SUBJECT: Industry Position Paper on Steam Generator Tube Deterministic Structural Limits (**Project Number 689**)

Subject: Transmittal of Industry's Position Paper on Steam Generator Deterministic Structural Limits.

**Technical Bases for
SG Tube Deterministic Structural Limits**

Figure 2-1: Distribution of Factor of Safety Against Burst
 Alloy 600 SG Tubes of Various Sizes

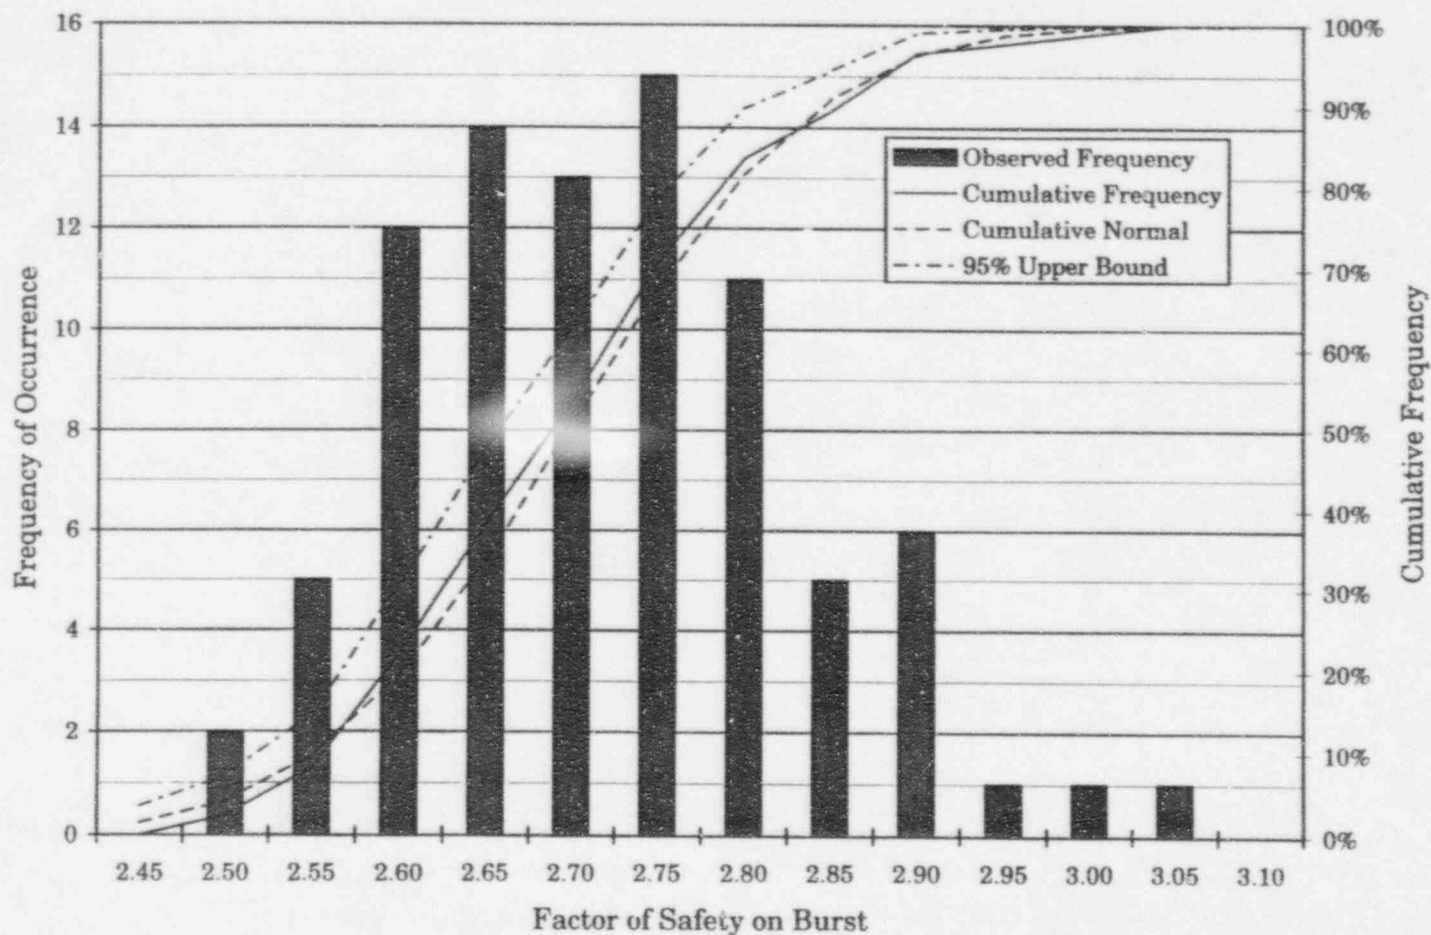
and data from NUREG/CR-0718. The average margin, i.e., the factor of safety, of the actual burst to the allowable operating pressure, determined using the ultimate tensile stress and the Code equation, is 2.7 (about 2.65 at 95% confidence), with a minimum of 2.5 and a maximum of 3.1. The results shown in Figure 2-1 indicate that the observed results may be considered to be normally distributed, thus, SF values even lower than 2.5 could be expected in a small percentage of additional tests. These differences between safety factors for analysis and for burst test data are further discussed in Section 4.1.

Information in Reference 4 shows that the yield to ultimate ratio for nominal 7/8" diameter mill annealed tubes is 0.44 at 650°F. For 3/4" tubes the corresponding ratio is 0.47. Thus, for each tube size, the true SF against burst is about 2.6, and not 3.0 as implied. As shown in Section 2.2 and Figure 2-1, the SF obtained using the ratio of measured burst pressures for undegraded tubes to Equation 1 is about 2.65 at 95% confidence which is consistent with the above derivation of the 2.6 factor of safety.
